# UNITED STATES PATENT AND TRADEMARK OFFICE

APPLICATION NO.	FILING DATE	FIRST NAMED INVENTOR	ATTORNEY DOCKET NO.	CONFIRMATION NO.
10/715,670	11/17/2003	Chiahua Ho	MXICP017	4806
25920 7590 12/27/2006 MARTINE PENILLA & GENCARELLA, LLP 710 LAKEWAY DRIVE SUITE 200 SUNNYVALE, CA 94085			EXAMINER PHAN, TRONG Q	
			ART UNIT	PAPER NUMBER
			2827

<b>Office Action Summary</b>	<b>Application No.</b> 10/715,670	<b>Applicant(s)</b> HO, CHIAHUA	
	<b>Examiner</b> TRONG PHAN	<b>Art Unit</b> 2827

## DETAILED ACTION

FIG. 4A

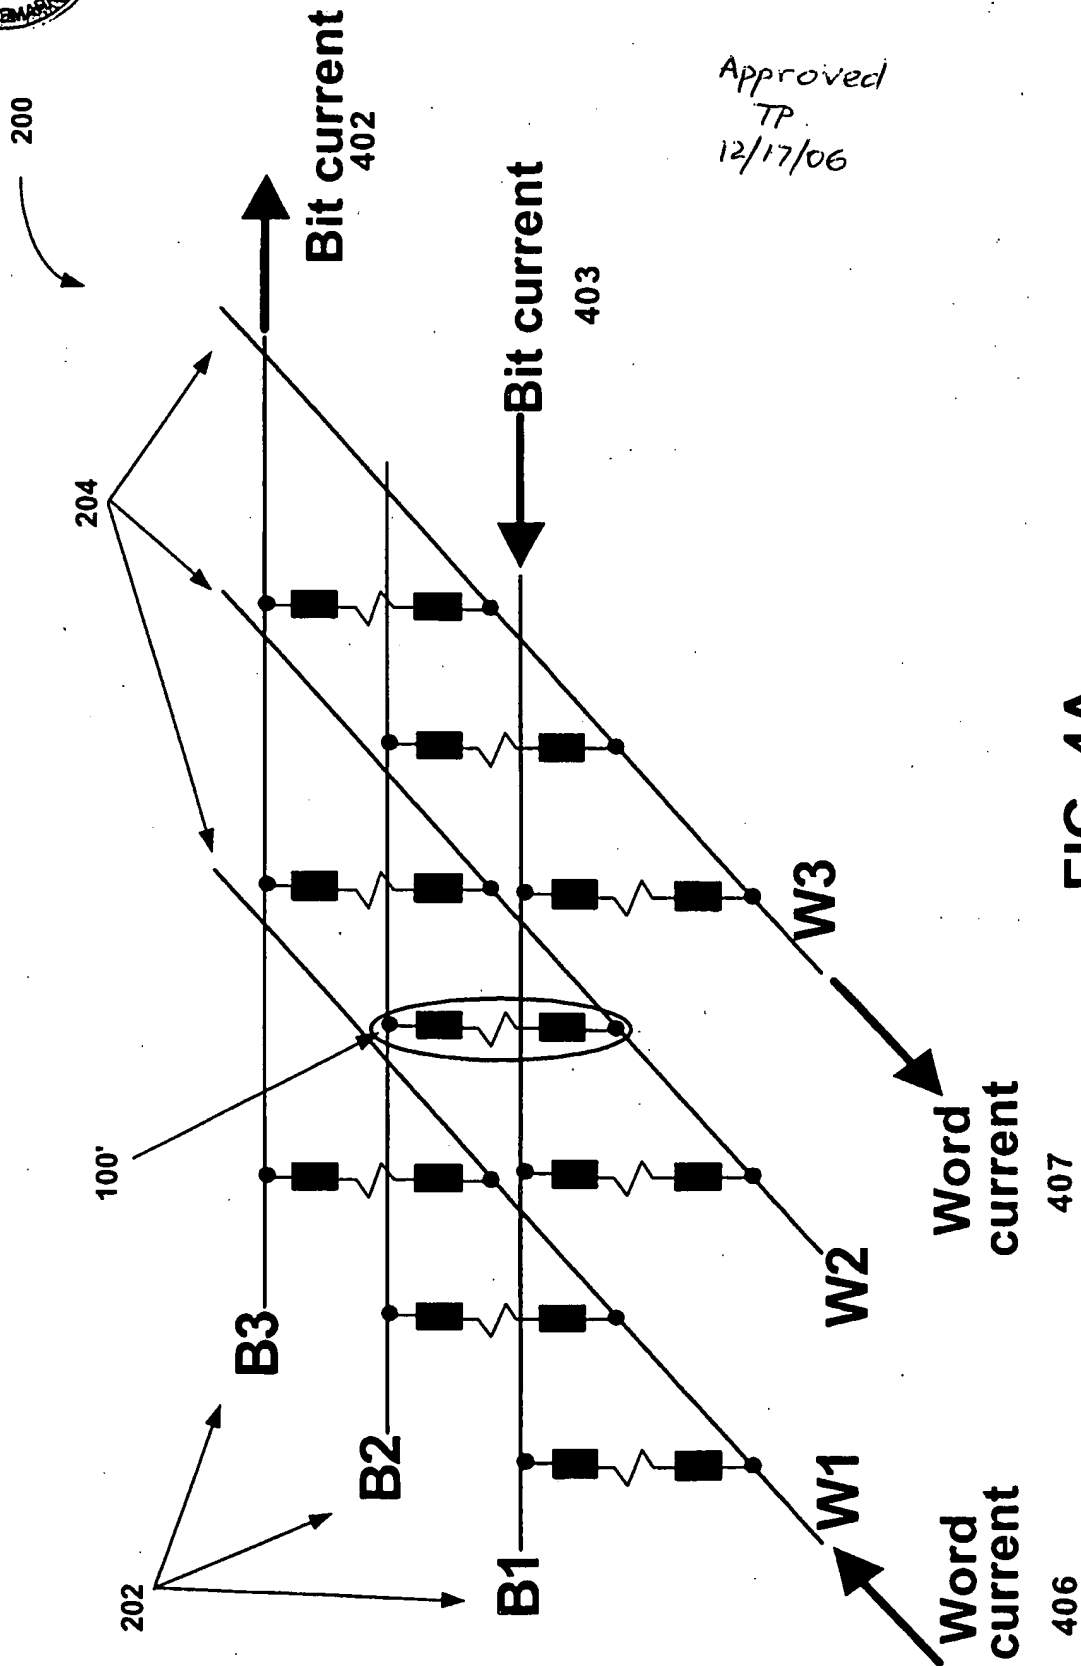
Regarding Fig. 4A, it is not understood how the method of programming the unit cell 100', which is coupled to bitline B2 and wordline W2 (see lines 1-3, page 8 of the original specification), to store a logic value 0 is not involved with anything to the directions of the currents placed on the bitline B2 and wordline W2.

FIG. 4B

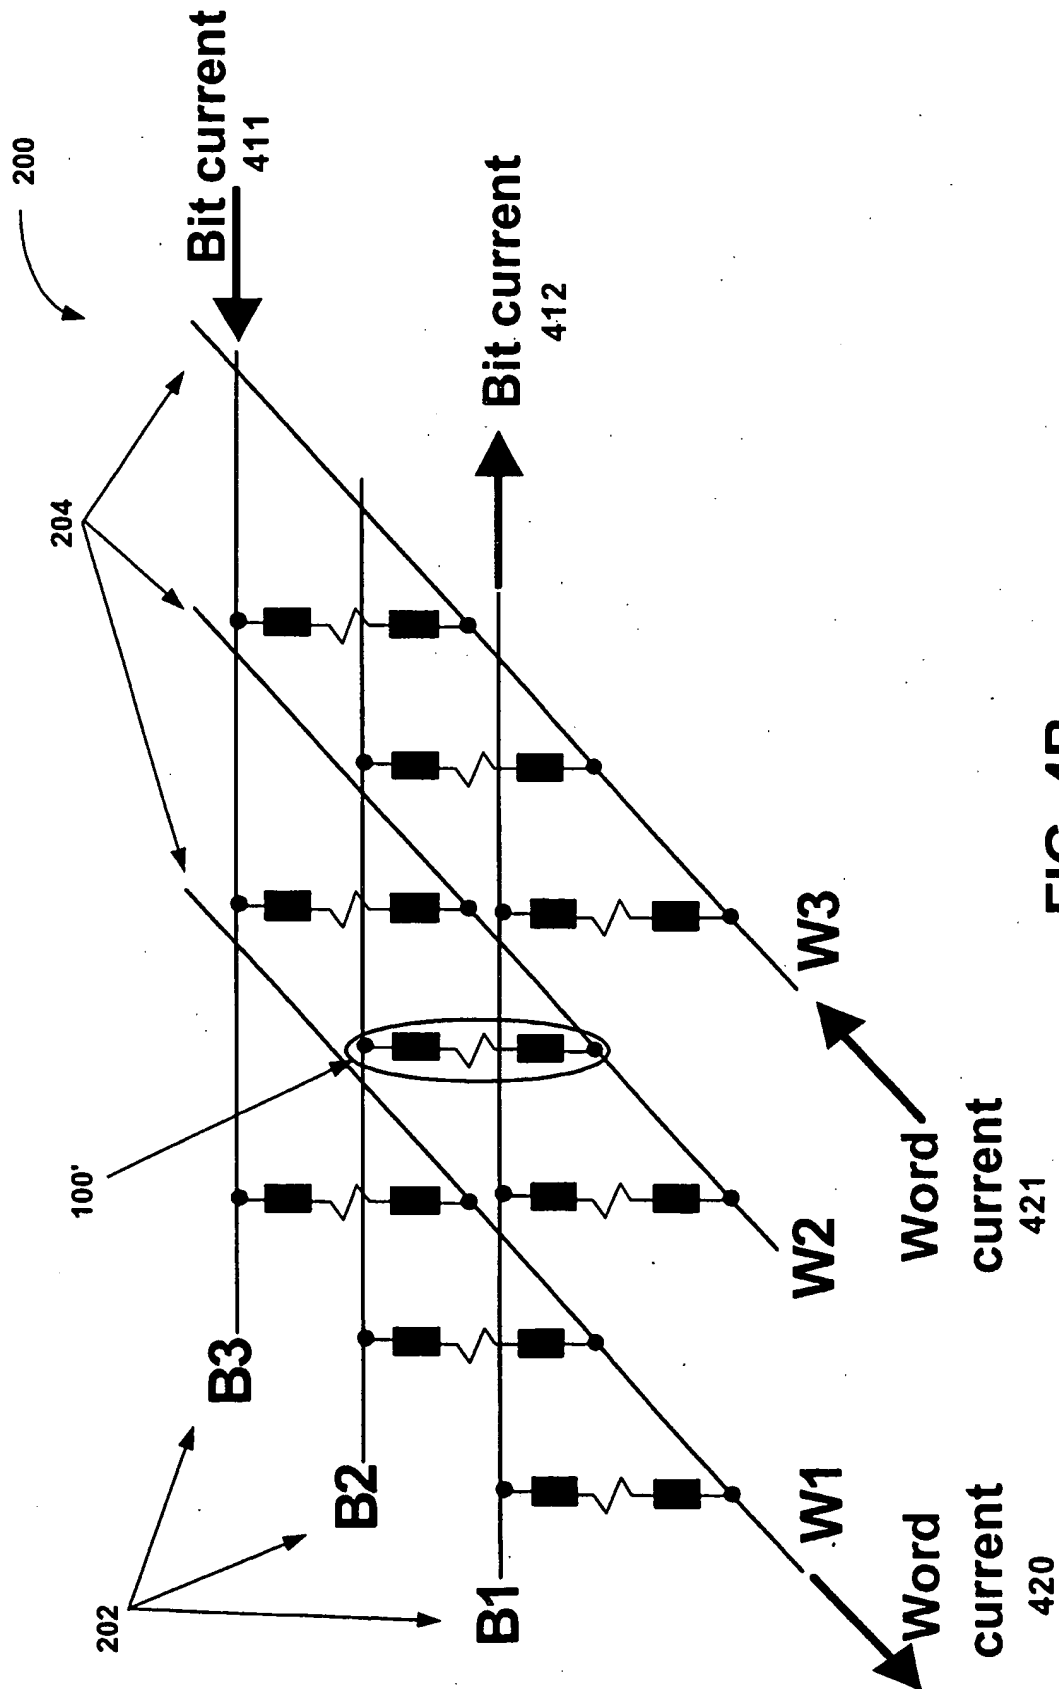
Regarding Fig. 4B, it is not understood how the method of programming the unit cell 100', which is coupled to bitline B2 and wordline W2 (see lines 1-3, page 8 of the original specification), to store a logic value 1 is not involved with anything to the directions of the currents placed on the bitline B2 and wordline W2.
